URGENT FIELD SAFETY NOTICE

GEHC Ref# 34095

RE: CARESCAPE R860 ventilator Inspiratory Safety Guard (ISG) – Potential for loss of ventilation

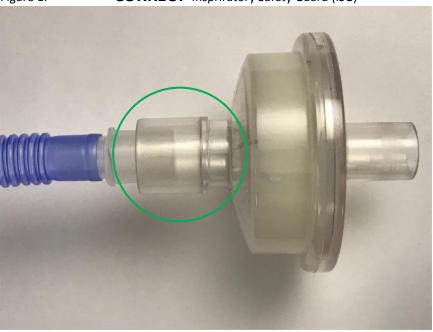
Safety Instructions 1) You may continue to use your ventilator with the ISG outlet if the 15mm female conical connector is inspected for a secure fit in the location indicated below where engagement resistance would normally occur (see figure 1).

- a. Ensure all breathing circuit conical connectors fit securely during initial breathing circuit assembly.
- Follow the instruction for use outlined in the User Reference manual 2065490-001 section 4: Setup and Connections.
- c. Run SYSTEM CHECK after patient circuit connection are made with all applied accessories outlined in Section 6 of the User Reference manual prior to connecting the patient.
- d. Set all alarms appropriately to ensure accurate and timely detection of sudden patient disconnect.
- e. No further action is required except to **complete and return** the attached "Customer Response" form checking box #1 to indicate that you **do not** have affected ISGs and e-mail to Recall34095.InspiratorySG@ge.com.

Figure 2: INCORRECT Inspiratory Safety Guard (ISG)

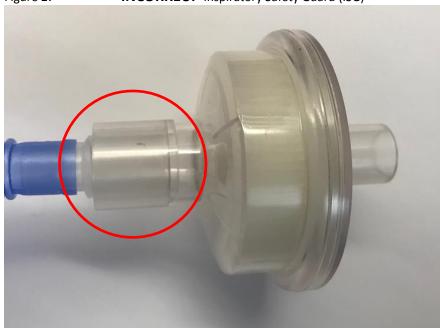
2) If the male connector looks like Figure 2, and freely slides up the entire length of the ISG female port, this indicates an incorrect ISG. In order to use the incorrect ISG you will need to use an adapter to ensure a pneumatic seal. If an adapter is not available, the ISG cannot be used for the 15mm connection.

If you have any incorrect ISGs, return to GE Healthcare or destroy on site, and **complete and return** the attached "Customer Response" form checking box #2 to indicate that you **do** have affected ISGs. E-mail the completed form to Recall34095.InspiratorySG@ge.com.
